**N4010A-08****S E R V I C E N O T E**Supersedes:  
NONE**N4010A Wireless Connectivity Test Set****Serial Numbers: MY46320255 / MY47230414**[Note: Additional units outside of this range are listed on the last page of this Service Note]**RF Assembly Reliability Issue****To Be Performed By: Agilent-Qualified Personnel****Parts Required:**

Figure 1

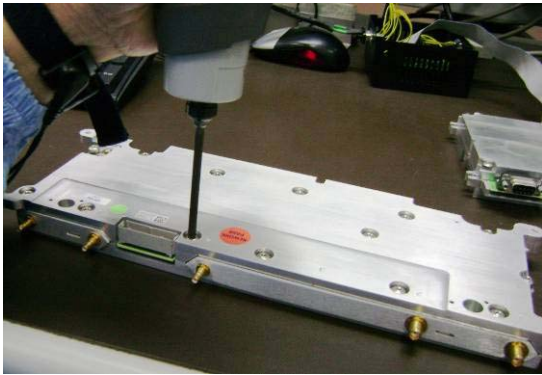
- (a) Remove the RF Assembly from the instrument.
- (b) Refer to Figures 1 and 2:  
Remove the 14 screws that secure the metal RF shield to the PCB. Carefully remove the top half of the RF shield, and the metal gaskets that are used to provide RF shielding. Please note the position and orientation of these parts, as they will be re-used during the assembly process.

Figure 3

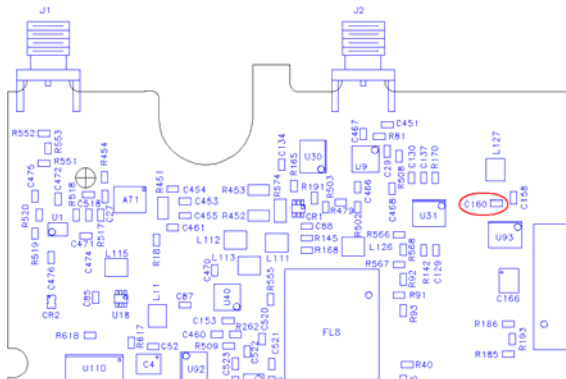
- (c) Refer to Figures 3 and 4:  
Locate capacitor C160, and check to see if it is burned-out. If it is burned-out then the RF Assembly must be completely replaced (part number N4010-69870).

Figure 4

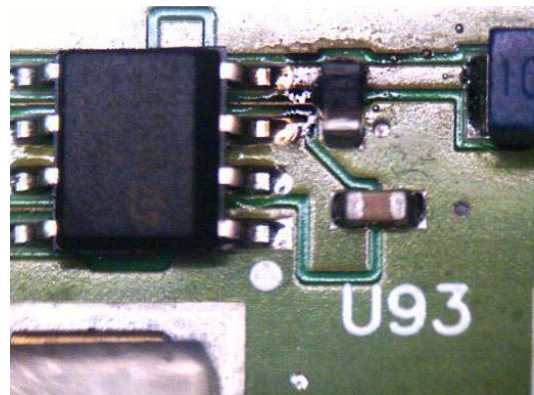
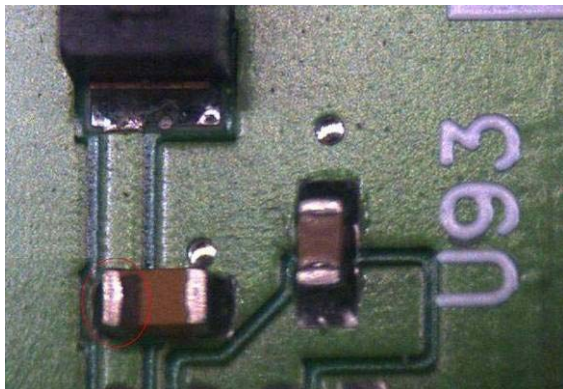
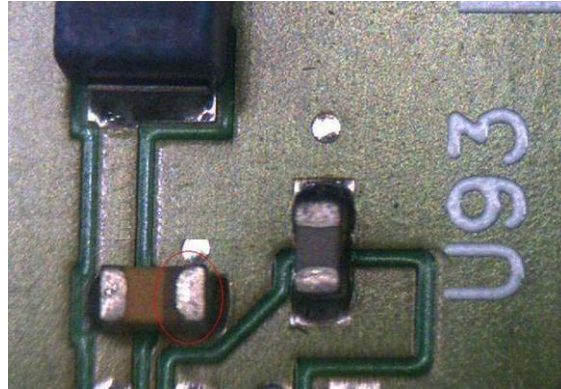
- (d) The polarity of C160 is indicated by a dark brown stripe at the positive electrode. The correct orientation of C160 is shown in Figure 5, whilst Figure 6 shows the wrong orientation of C160. If the orientation of C160 is correct, then proceed to step 2(g), otherwise continue to step 2(e).

- (e) Use a hot air solder station (set to 380°C) & tweezers to remove C160 as shown in Figure 7. Use the same settings to heat the solder on the pad and replace C160 (part number 0181-0233).  
Note: Do not apply hot air directly to the device, as it may be damaged by over-heating.

- (f) Use a manual soldering station (set to a maximum of 370°C) to touch-up the solder fillets on both sides of C160 as shown in Figure 8.

*Figure 9*

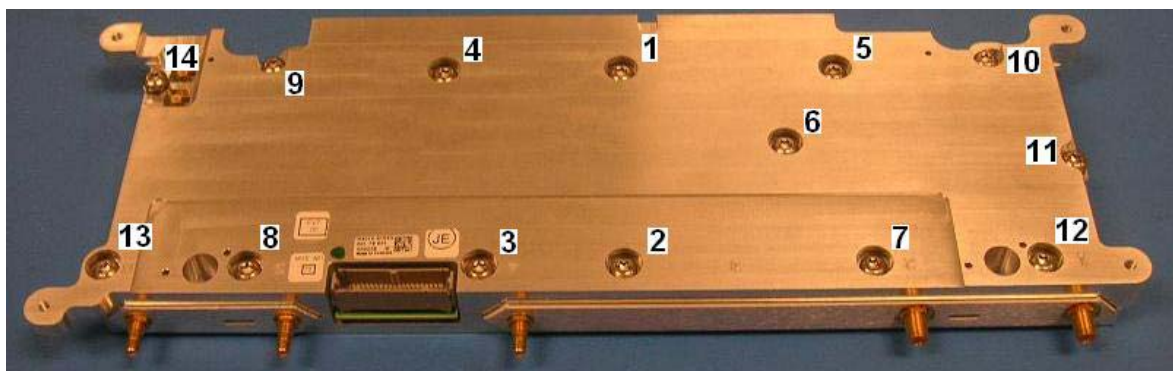
- (g) Place the metal gaskets on the PCB, ensuring the position and orientation of each one is correct. Carefully fit the top half of the RF shield, and tighten the 14 screws to 21 in-lbs (2.37 Nm) using the sequence shown in Figure 9.

Note: Repeat the tightening process once more to ensure the RF gasket is fully compressed.
